Permit Number: 061674  
**PERMIT ISSUED**  
DEC 19 2006

This is to certify that AMORY IONATHAN / Whelan Callender Architects  
has permission to Add 3rd unit w/ interior renovations to a kitchen, bath, living room & bedroom  
AT 156 SPRUCE ST 056 G02100

**TRANSMITTAL****DATE:** January 22, 2007**TO:** City of Portland  
c/o Capt. Greg Cass/Building Inspections  
389 Congress St.  
Portland, ME. 04101**RE:** 56 Spruce Street**WE ARE SENDING YOU THE FOLLOWING ITEMS:**

## TRANSMITTAL

56 SPRUCE ST.  
 STAIR DIAGRAM -  
 - EXISTING SHOWN SOLID -  
 - PROPOSED SHOWN DOTTED

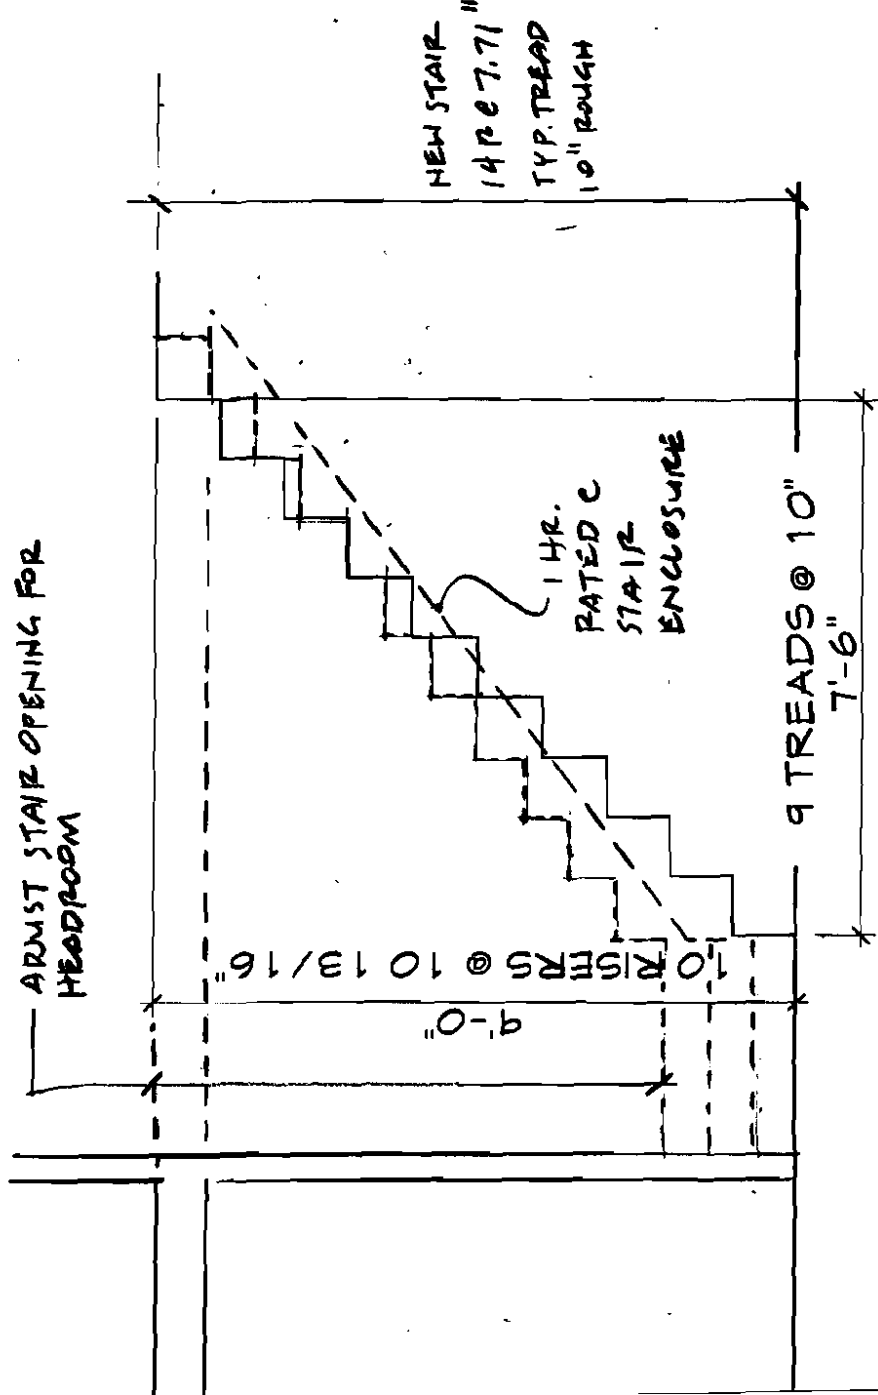
We are also proposing improving the existing stair to the upper unit to be a 7 1/2" riser rather than the existing riser in excess of 10".

NEW STAIR  
 14 R @ 7.71"  
 TYP. TREAD  
 10" ROUGH

1 HR.  
 RATED C  
 STAIR  
 ENCLOSURE

9 TREADS @ 10"  
 7'-6"

9'-0"  
 10" RISERS @ 10 13/16"

FLOOR FRAMING DETAIL

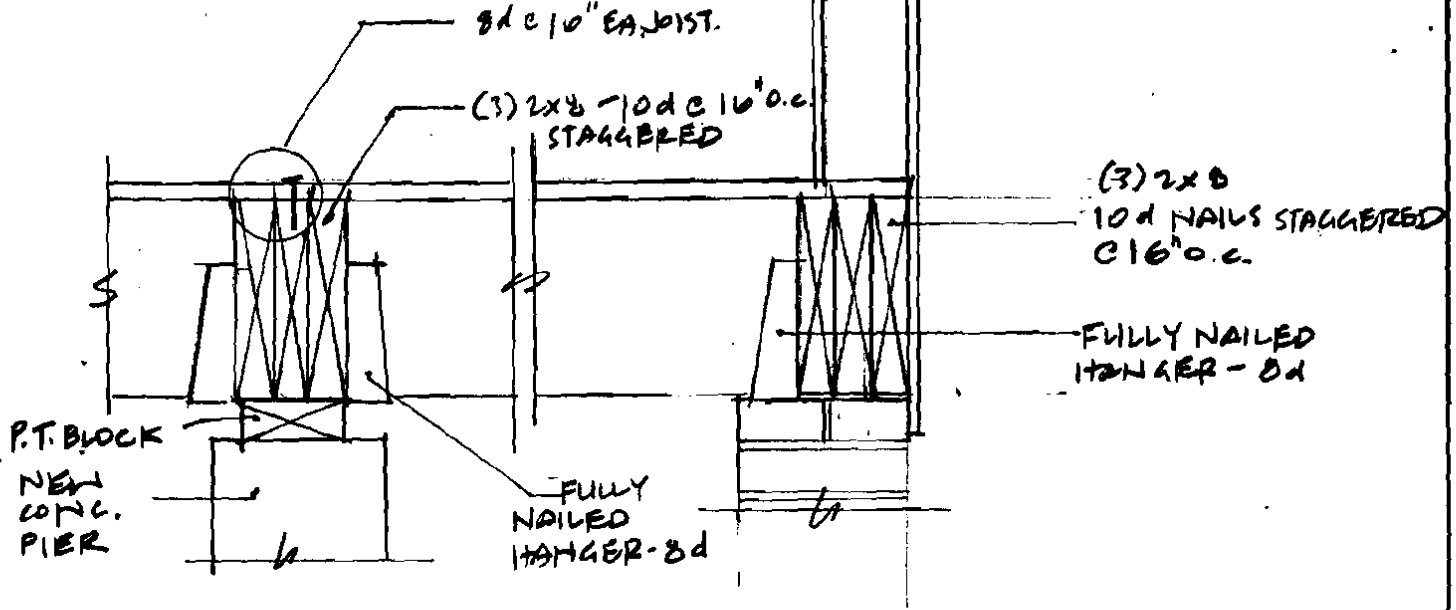
- 1) Construction Budget to Justify the submitted construction Cost. WILL DO
- 2) Complete framing details for all construction including fastener schedule, hangers, headers, beams/girders etc. WILL DO

- Item 1- Construction Budget attachment
- Item 2- Sketch #1 Framing details for proposed floor and roof construction.
- Item 3- See attached plans- Rated wall between proposed unit and existing spaces will be a UL 365 partition. Rated floor to be UL L537, see attached.
- Item 4- Sketch #2 for Stair detail and Bulkhead detail.
- Item 5- Sketch #3 for egress window.
- Item 6- There are no proposed penetrations at the rated walls.
- Item 7- See Sketch #2.
- Item 8- See attached IRC code.
- Item 9- See attached deck detail. I'm not exactly sure how to prove this detail with reference to 1607(BOCA ?). We are using solid cedar posts, through bolted to deck framing, screwed with 4" non corrosive fasteners. I think we will be stronger than most rail assemblies, especially the vinyl systems.

Design No. U365  
Bearing Wall Rating — 1 Hr  
Finish Rating — 18 Min

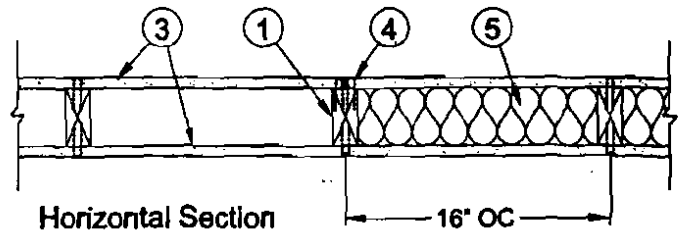
- 3A) Fire separation assembly details with STC ratings and UL Listings WILL DO
- 4) Stair details that show treads, risers,width, headroom, nosings and handrail details. WILL DO
